# Modification Recommended Service Note

Supersedes:  
U7179-81000-01

## U7179-81000 - 16-Channel High Current Load Card up to 15A

Figure 1. TestExec error

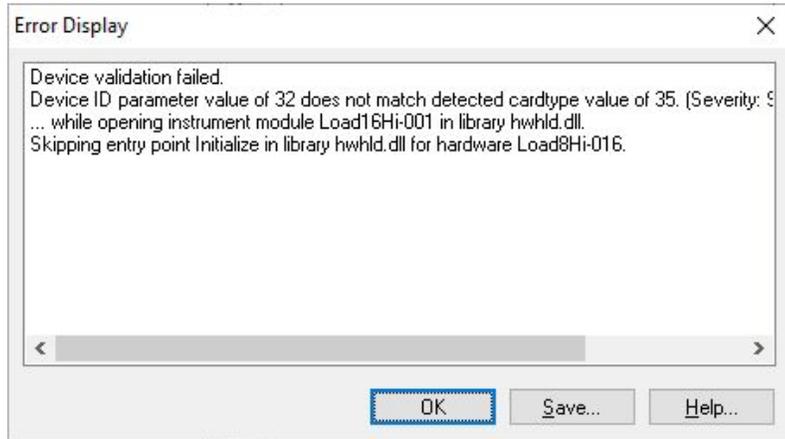
When all load cards are populated in the E6198B SLU (refer to Figure 2), the hardware ID of the U7179A load card in the left-most slot (slots 1 or 3) is not recognized correctly. The correct ID for U7179A card is 32, while the invalid IDs that have been observed could be 33, 35, 36, 37, 38, 39, 40, 41, 44, 46, and 47 (not fixed).

i.e. TestExec gives the following error message when it starts:

When the U7179A load card encounters a wrong hardware ID detection issue and the U23 IC on the U7179A load card is recognized as being from the NEXPERIA or NXP manufacturer, replace the U7179A load card with a new card (U7179-81000 or U7179-89000). Otherwise, assume there are no timing issues with the U7179A load card and do not proceed with this service instruction.

Figure 2. SCE screenshot

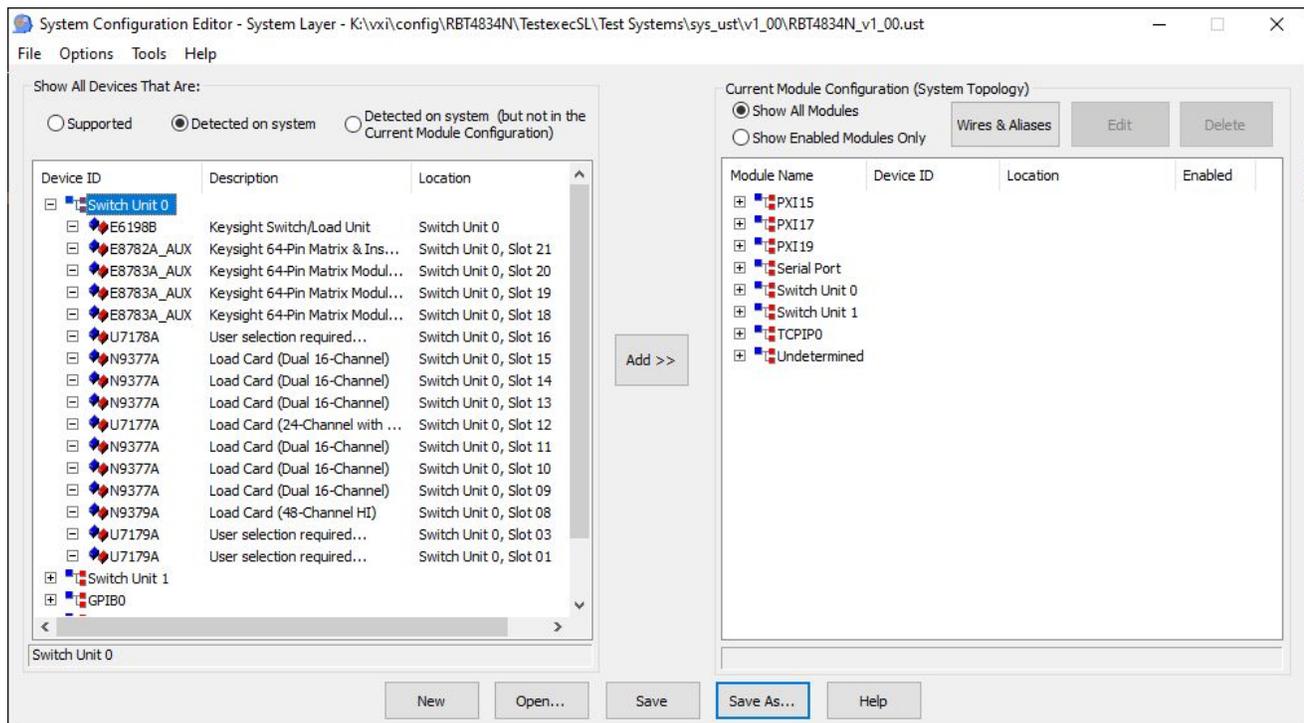
Hardware ID detection error only occurs if there are 10 or more cards in the SLU and happens at the left-most slot of the U7179A card. It is determined that a delay in control signals that are fed to the ID

IC from the specified manufacturers will result in a different U7179A ID. This delay causes the time mismatch on the timing diagram thus affecting U7179A ID signals.

Manufacturer Identification

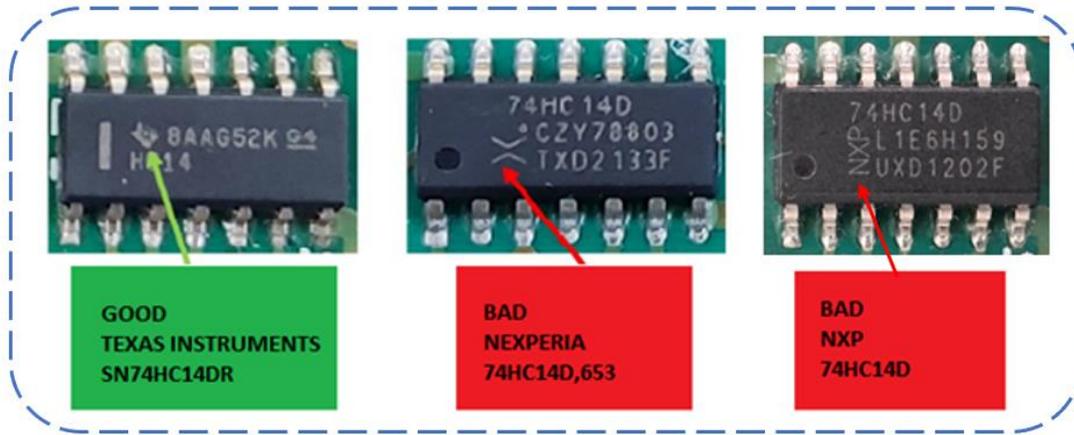
1. Perform a visual inspection to verify component body markings on the IC U23.

2. If the manufacturer mark indicates NEXPERIA or NXP, the card is identified as affected.
3. If the manufacturer mark indicates TEXAS INSTRUMENTS, no action is required.
